## **Sheridan East**

From Wheaton/Warren to Perry Ave. Sheridan climbs steeply from both ends, cresting at Schley/Olympus Road in the middle.

WSCC recommended road markings and improvements indicated by red boxes.

## Location 1. Sheridan Wy. intersection at Wheaton, looking east.

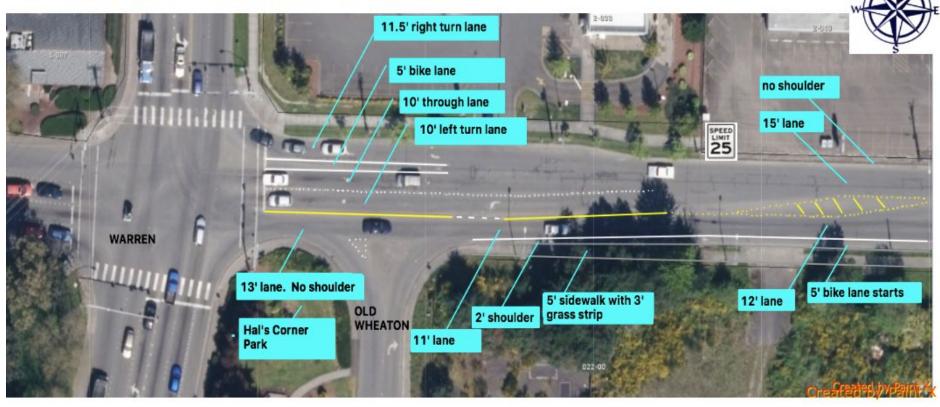
Existing westbound 5' bike lane is seen at position A. No eastbound bike lane until position B

Location 1. Current conditions.

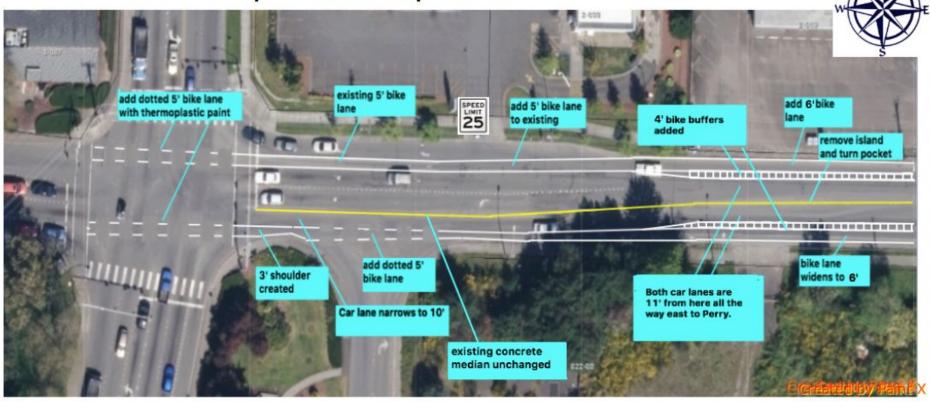
Existing westbound through bike lane at intersection, but no shoulder or bike lane leading up to the bike lane. No shoulder or bike lane for eastbound bike traffic crossing Warren onto Sheridan

Location 1. Proposal for improvement

Bike lanes cross Warren Ave, connecting both sides of Sheridan. New, marked bike lane is added to connect to existing westbound bike lane. Turn pocket onto Spruce Ave is eliminated, allowing wide bike lanes and car lanes. Narrow shoulder is created at Hal's Corner by narrowing car lane.
